UNITED STATES PATENT AND TRADEMARK OFFICE

APPLICATION NO.	FILING DATE	FIRST NAMED INVENTOR	ATTORNEY DOCKET NO.	CONFIRMATION NO.
09/909,845	07/20/2001	A. John Speranza	PES-0042	8798
23462	7590	12/19/2003	EXAMINER	
CANTOR COLBURN, LLP 55 GRIFFIN ROAD SOUTH BLOOMFIELD, CT 06002			SINES, BRIAN J	
			ART UNIT	PAPER NUMBER
			1743

Office Action Summary

DETAILED ACTION

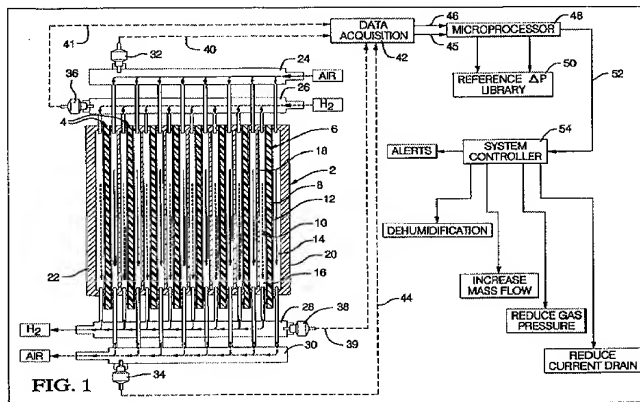
Claims 1 – 28 are rejected under 35 U.S.C. 102(b) as being anticipated by DiPierno Bosco *et al.* (U.S. Pat. No. 6,103,409 A). Regarding claims 1 – 12, DiPierno Bosco *et al.* teach a method and apparatus for monitoring and controlling the operation of proton exchange membrane fuel cells. DiPierno Bosco *et al.* teach an electrochemical fuel cell apparatus

comprising: an electrochemical cell (4); an energy source (26) configured for providing a quantity of energy to the electrochemical cell; a sensing apparatus (32); and a computer (42 & 48), wherein the computer further comprises: a memory device; and a processor (see col. 3, line 65 – col. 5, line 62; figure 1).
